PLANNING ASSESSMENT REPORT – SYDNEY EASTERN CITY PLANNING PANEL

2017SCL060, No's 68-72 Railway Parade and 2-10 Oxford Street, Burwood

Report Author:	Burwood City Council
Date of Report:	1 June, 2018
Property Address:	68-72 Railway Parade and 2-10 Oxford Street, Burwood
Proposal:	Development Application No. 124/2017 – Demolition of existing structures and construction of a six to ten storey mixed use development comprising 124 apartments, one retail premises at ground floor, and three levels of basement car parking.
Applicant:	X-Sealant Pty Ltd
Zone:	R1 – General Residential – Burwood Local Environmental Plan (BLEP) 2012

Figure 15. Ground Floor Plan diagram showing the proposed condition to consolidate the two bin rooms and improve accessibility.

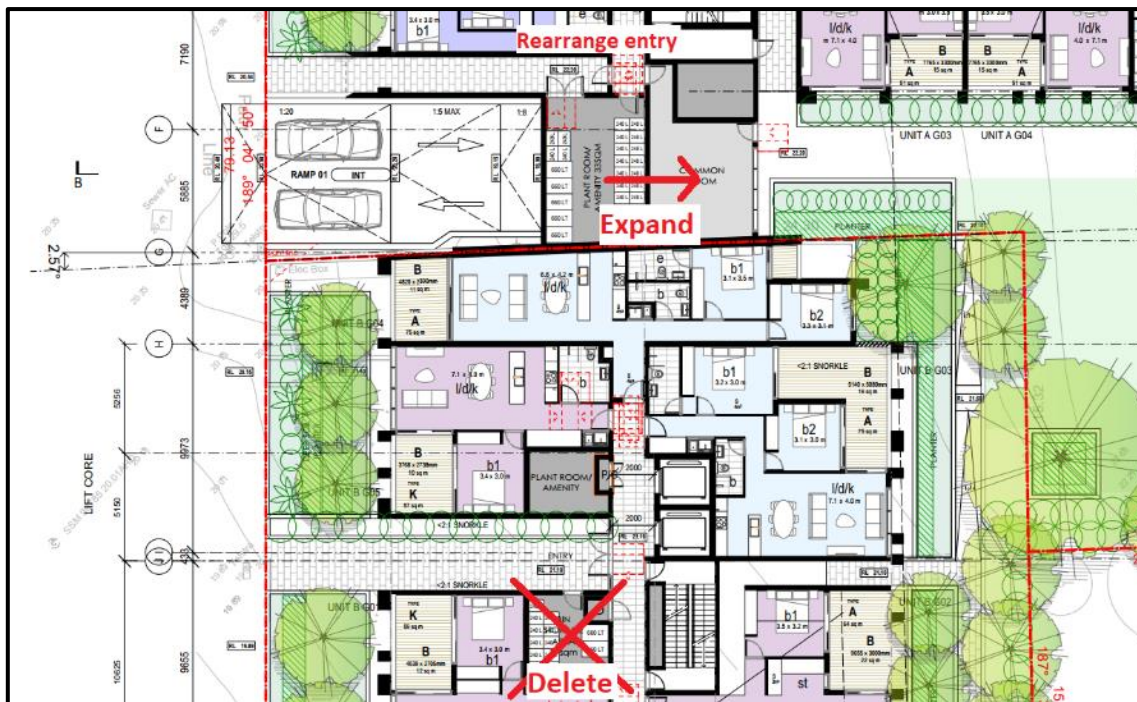
The amended proposal has deleted the bin area adjacent to the street and replaced it with two separate internal bin rooms at ground floor within Stage 1 (north) and Stage 2 (south). The revised arrangement is not supported as having two separate bin rooms will be inconvenient for transfer and collection of bins and the rooms provided are not easily accessible from the street.

To resolve this issue, there is scope to consolidate the bin rooms by expanding the northern bin room and deleting the southern bin room. The northern bin room can be expanded into the adjacent common room which can be relocated to the roof top communal space. The rooftop is considered a more desirable location for the common room as it will receive better solar access and natural ventilation as compared to this dark and poorly located ground floor space. To ensure the bin room facilitates easy transfer and collection of bins, the entry doors will also need to be rationalised and widened. This revised temporary bin storage room has been conditioned as below and the intended effect is illustrated in **Figure 15**.

Condition – The southern temporary waste bin storage room on the ground floor is to be deleted and the northern ground floor waste room expanded commensurately. The northern waste room is to be expanded into the adjacent common room and the entry area to the new room is to be rationalised to allow for wide and easy access for the transfer of bins in and out of the room. The common room is to be relocated to the rooftop communal area and is to have minimum dimensions of 4m. The space of the southern bin room may be incorporated into the adjacent apartment.

Figure 17. Marked amended northern elevation showing the stepped down bulk to minimise impacts on adjoining school (Source: Alexandar Design Group, 2018 / Marked: James Arnold, 2018)

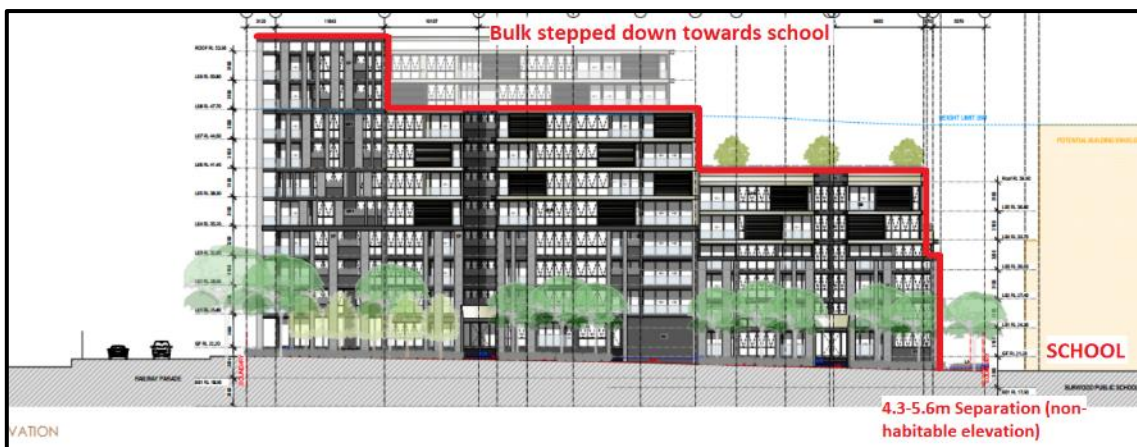
In response to Council’s requests, the applicant submitted a significantly revised proposal which shifted the bulk and height of the development to the north of the site, allowing for a reduced built form of 6 storeys adjacent to the school in the south of the site. The amended built form as viewed from Oxford Street is shown in **Figure 17**. As part of the amended set of plans, overshadowing diagrams compare the shadows of the originally submitted proposal to the amended proposal. These diagrams indicate significant improvements for solar access to the adjoining playgrounds. It is estimated that at the worst time of year for solar access (June 22) that the adjoining playgrounds will receive direct sunlight to at least 50% of the space throughout the day between 9am and 3pm. During the key times of 11am to 1pm when the playgrounds will be most heavily utilised, the diagrams indicate shadowing to only a minor portion near the boundary with the site. The middle of the playground and the multi-purpose courts will be mostly unaffected during those hours. The primary portions of the playground are shown in **Figure 18**.

Figure 18. Aerial image of the site and the adjoining school playgrounds. The primary portion of the playgrounds is identified (Source: maps.google.com.au / Marked: James Arnold, 2018)

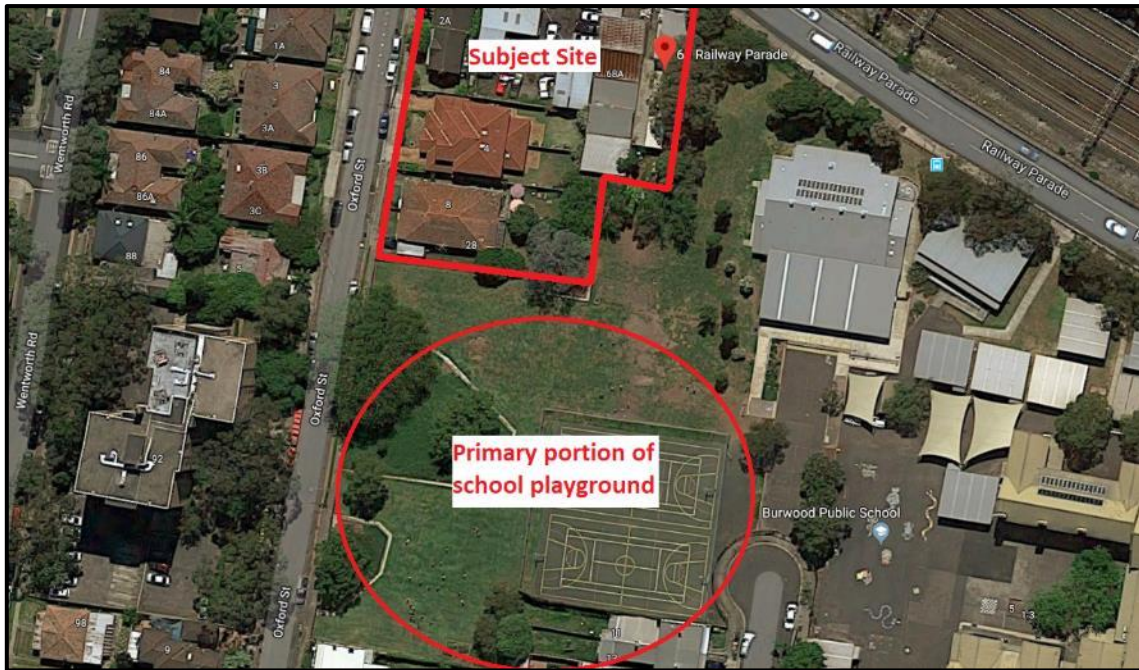
In considering the appropriateness of overshadowing impacts on the school playgrounds, there are no specific planning controls that are applicable. Accordingly, the impacts have been assessed on a merit basis. Having consideration for the impacts that would be anticipated from the development controls that apply to the subject site and the amendments to the built form that have been undertaken to minimise those impacts, the overshadowing impact is considered acceptable.

Figure 19. Marked floor plan showing separation distances from habitable areas to boundaries and views to the main part of the playground will be cross views and obstructed by vertical fins (Source: Alexandar Design Group, 2018 / Marked: James Arnold, 2018)

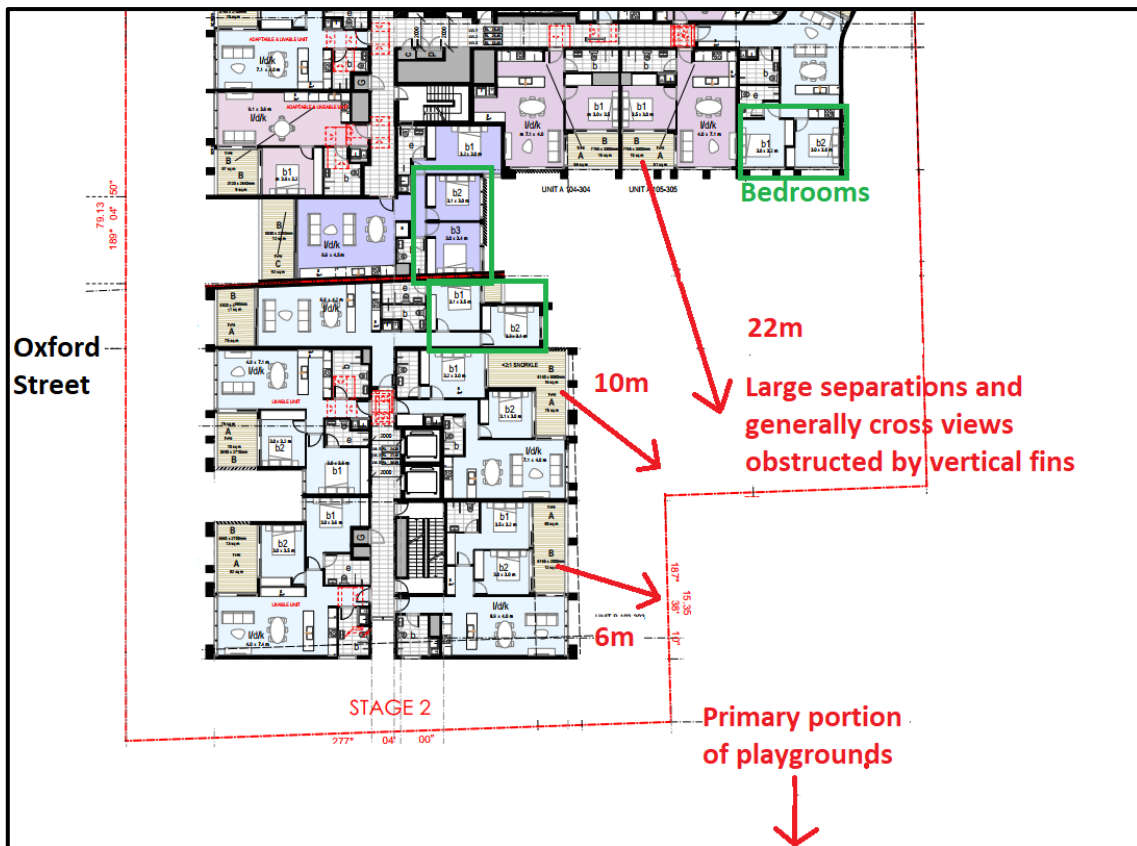
Comment: The issue of privacy and potential overlooking from the development to the adjoining playgrounds of the Burwood Public School has also been considered extensively in the assessment of the proposed development. The proposal as originally lodged with Council provided a blanket 8 storey built form across the subject site. The proposal has been amended to shift the bulk of the development, and therefore the majority of apartments, to the northern portion of the site, away from the school playgrounds. The amended proposal now includes reduced bulk, in the form of a 6 storey element, to the southern portion adjacent to the school which has also minimised the amount of apartments within this portion of the site.

When considering privacy impacts, the applicable planning controls for this development are provided in the Apartment Design Guide. Privacy is primarily achieved via separation distances from apartments to the boundaries. The proposal complies and significantly exceeds the ADG requirements which stipulate a minimum 3m separation from non-habitable openings to boundaries and 6m from habitable openings to boundaries. The habitable areas and separation distances from the apartments that face the school boundaries to the south and east are shown in **Figure 19**. As shown, the minimum distance is 6m for only six apartments in the southern portion of the building. The remaining apartments are separated by 10-22m from the boundary and any views to the main portion of the adjoining school playground are cross views and highly obstructed by the vertical fins proposed on the facades of the building.

Given the above, the proposal achieves and generally far exceeds the applicable privacy provisions. Overlooking from the development to the adjoining school playgrounds has been minimised as far as practical and as such is considered to be acceptable.
